**CERTIFICATE OF APPROPRIATENESS**

**Property:** 1201 Arlington Street, Lot 12 Block 89, Houston Heights East Subdivision. The property includes a historic 1,692 square foot Contributing Brick Bungalow Duplex, a 548 square foot Contributing Garage Apartment, and a 1,147 square foot Contributing Brick Bungalow situated on a 6,600 square foot (50' x 133') corner lot. The scope of this project is limited to the garage apartment.

**Proposal:** Alteration – Addition

**Recommendation:** Denial - does not satisfy criteria

**SOUTH FACING EAST 12<sup>th</sup> STREET**

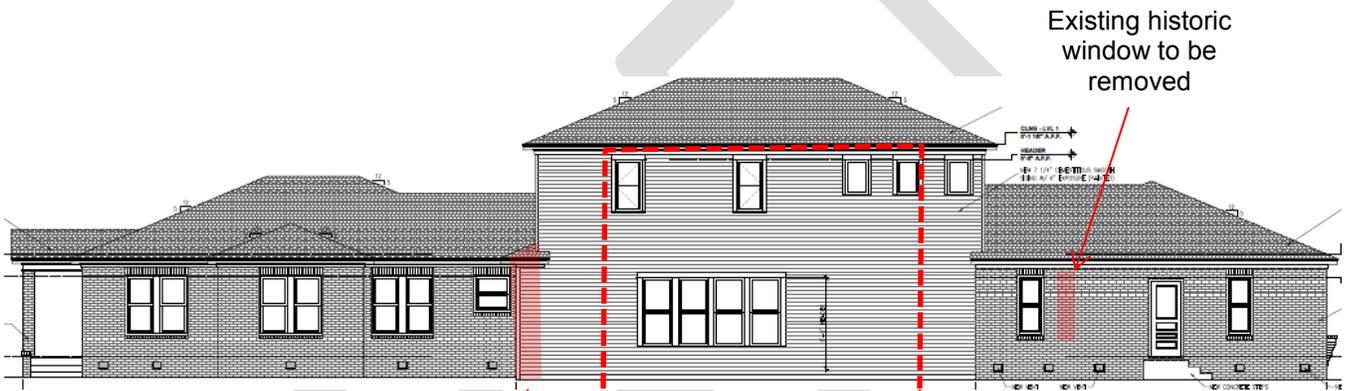
*The proposed addition creates a single large structure, which is of an incompatible size and scale compared to two smaller separate structures and other Contributing structures found within Houston Heights Historic District East. The proposed painting of the existing unpainted brick cladding destroys a significant amount of historical and architectural material. Additional historical material is proposed to be removed in order to construct a north facing bump out on the Bungalow Duplex and removing a north facing window on the Bungalow.*

- (10) The proposed alteration or addition must be compatible with the massing, size, scale material and character of the property and the context area;  
*The proposed addition creates a single large structure, which is of an incompatible size and scale compared to two smaller separate structures and other Contributing structures found within Houston Heights Historic District East.*
- (11) The distance from the property line to the front and side walls, porches, and exterior features of any proposed addition or alteration must be compatible with the distance to the property line of similar elements of existing contributing structures in the context area.

- **Revise the addition to limit its size to roughly within the footprint of the existing garage apartment that was approved to be demolished.**
- **Connect the Bungalow and Bungalow Duplex to the new addition by small hyphens.**
- **Do not construct a unifying roof structure over all three structures.**
- **Do not remove a historic window on the Bungalow.**
- **Do not bump the wall out at the rear of the north elevation of the Bungalow Duplex.**
- **Do not paint the existing unpainted brick cladding.**

**NORTH SIDE ELEVATION**

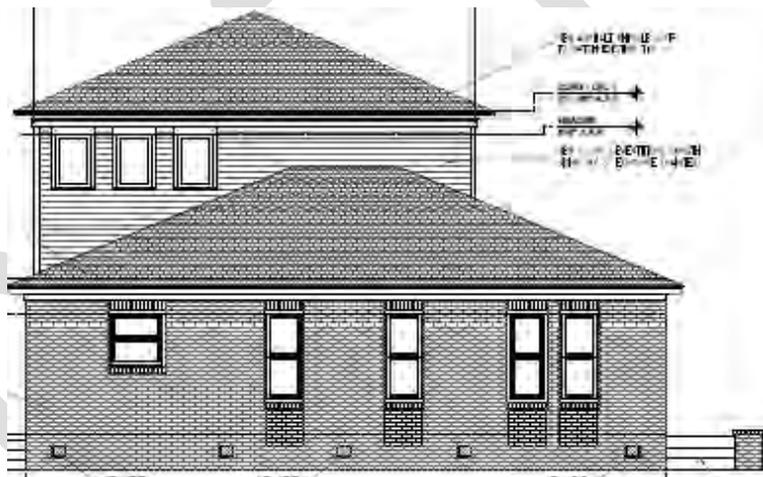
Existing historic window to be removed

Master closet bump out on the north side of the existing Bungalow Duplex

FIRST FLOOR PLAN

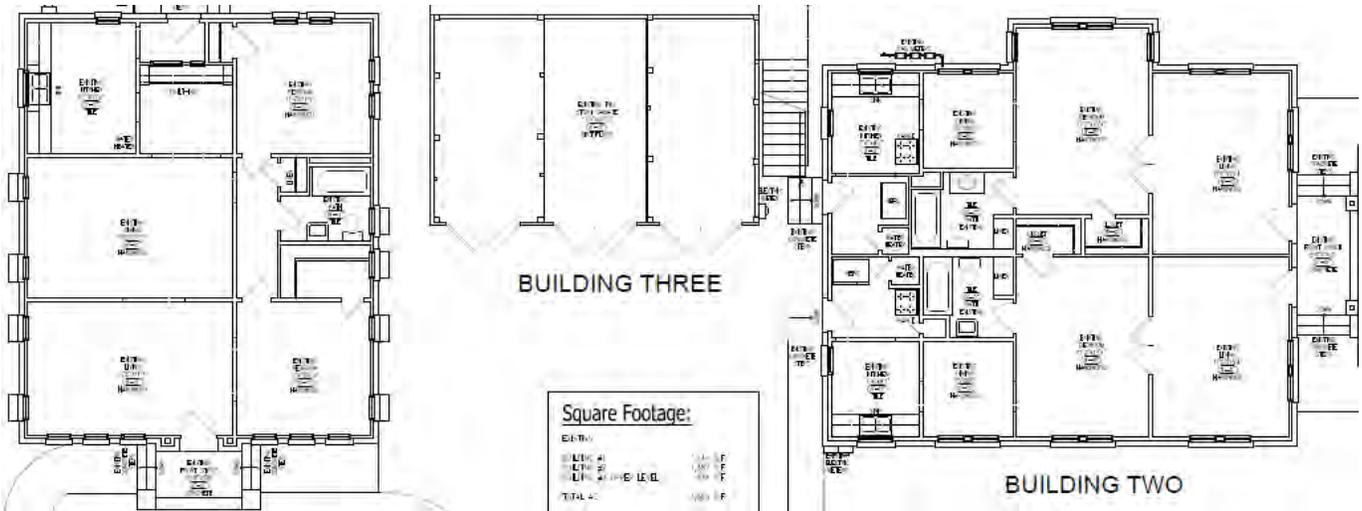
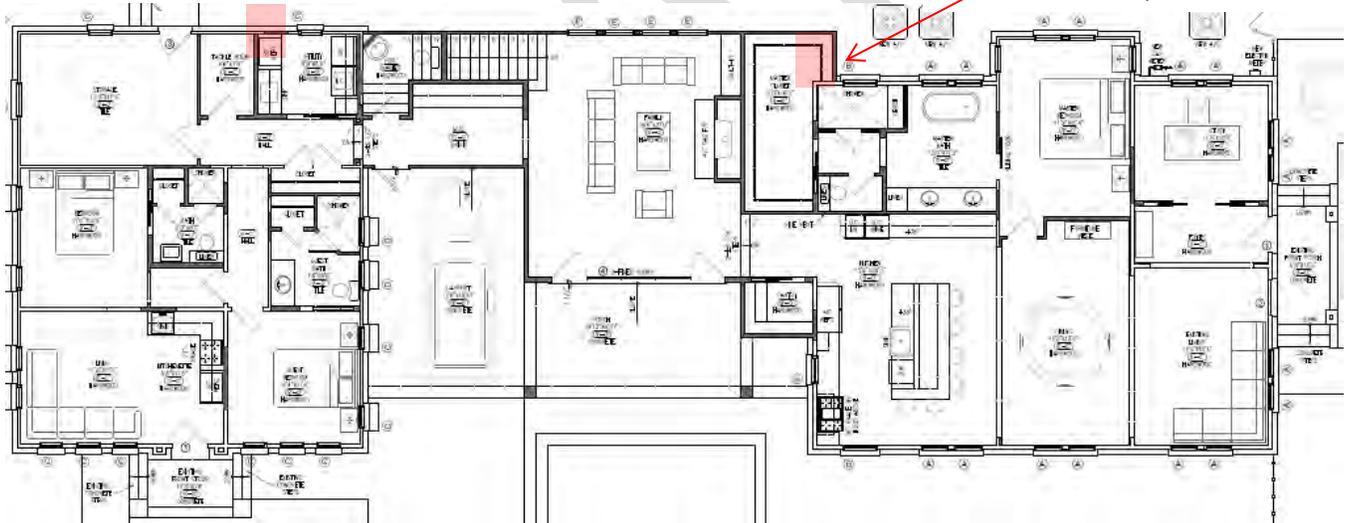
Existing historic window to be removed

Master closet bump out on the north side of the existing Bungalow Duplex
